Report: TAB REPORT
Function: Test, Adjust, & Balance
Date: 02/16/2024

PROJECT
02-05-24 PERRY'S - VERNON HILLS, IL

Issue List

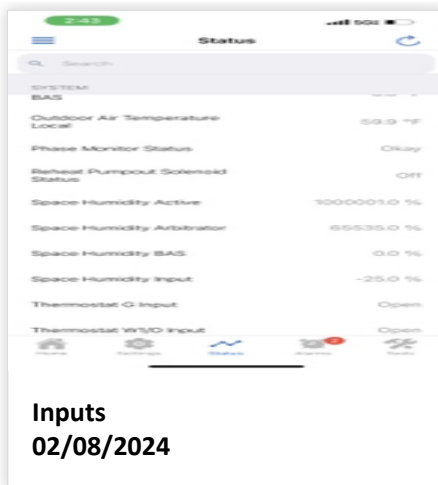
Issue Name : 01. Symbio RTUs: Humidity Alarm
Description : All Symbio RTUs have an alarm regarding space humidity input. Space humidity is being displayed as 1000001.0% at the RTUs. Space humidity arbitrator displays 65535.0%. Space humidity input displays -25.0%. Unsure how or if RTUs are reading space humidity. No sensors installed. Recommend Trane / EOR is contacted for clarification.

Issue Name : 06. RTU-4: High on airflow

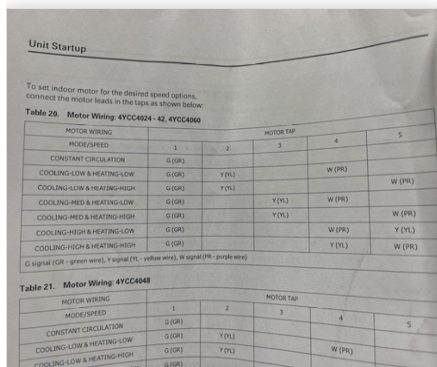
Description : RTU-4 is multispeed unit scheduled for 600cfm with speed taps. Plans call for constant volume. Unit is within design at Speed tap 1, where G is landed. Manual indicates placing W(heat) at 4 and Y (cool) at tap 2, puts heating and cooling to low speed, this is 940cfm. Not possible to wire all stages to same speed. No indication if jumpers are allowed.

EF-5

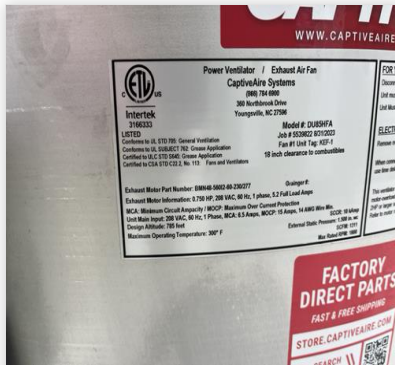
Issue Name : 07. EF-5 (Smoker): High on Airflow
Description : EF-5 measured at 1343/1000 cfm. Fan does not have a speed controller installed and no speed control is listed in exhaust fan schedule. EF-5 is to be controlled through smoker operation, but control is not fully functional. Control bypassed and fan measured at max single speed.
Created By : National TAB **Assigned To :** National TAB - Michael McDonnell
Status : Open
Priority : Low **Asset Tag :**
Originated Date : 02/15/2024 - Michael McDonnell - National TAB

- **02/15/2024 National TAB - Michael McDonnell**
 - A speed control will need to be installed and functional to bring EF-5 into design. Not anticipated to cause any issues as EF-5 only operates when smoker is fully evacuated of smoke.
